Permit Application Review

Permit No. 2019-139  
Received complete: November 25, 2019

Applicant: Dean Williamson: Frauenshuh, Inc.  
Consultant: Vicki Van Dell; Loucks, Inc.  
Project: Parking Lot Expansion for Creekview Office Building  
Location: 7101 West 78<sup>th</sup> Street: Bloomington  
Rule(s): 2,3,4,5,11,12  
Reviewer: BCO

**SITE PLAN  
C2-1**

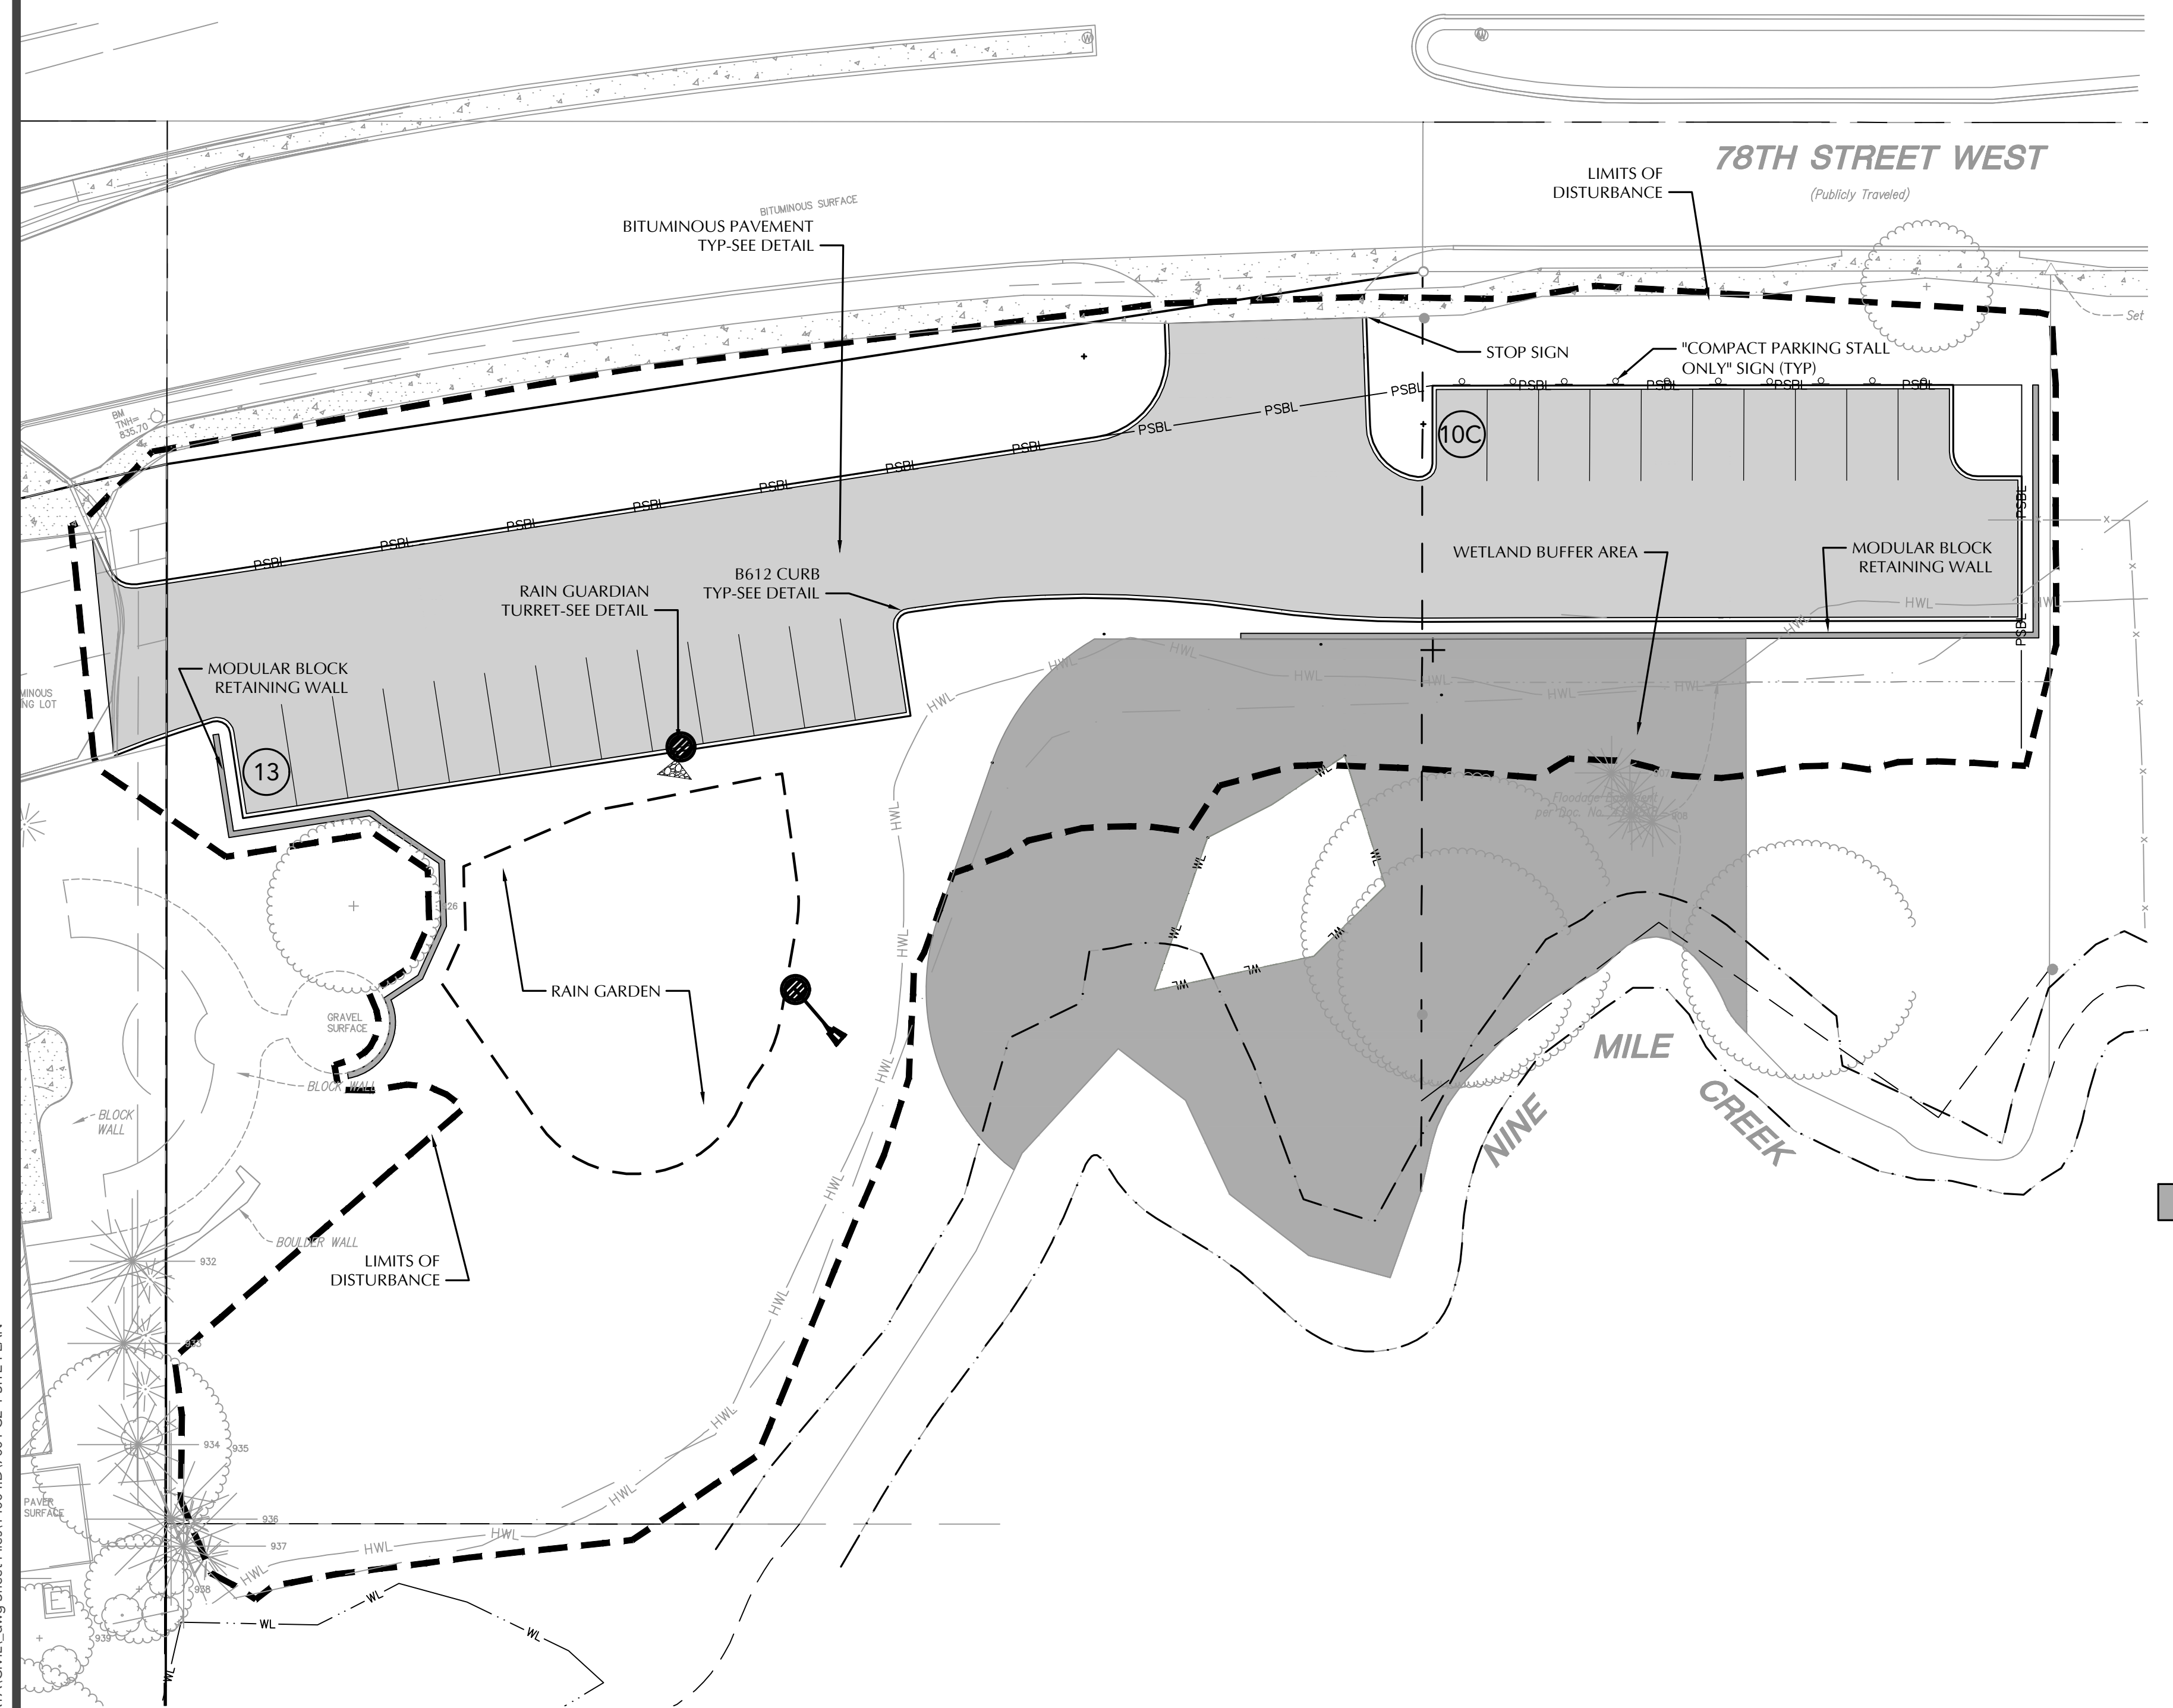
Rule 2.3.4 states that, *no structure may be placed, constructed or reconstructed and no surface may be paved within 50 feet of the centerline of any water course.* The minimum distance between the parking lot and the centerline of the creek is 55 feet, complying with Rule 2.3.4.

An area of 12,550 square feet is required for the 40 foot average buffer. The plans show a buffer area of 12,555 square feet will be provided. The closest point between the proposed modular block wall and the wetland boundary is 43 feet, a minimum of 20 feet is required.
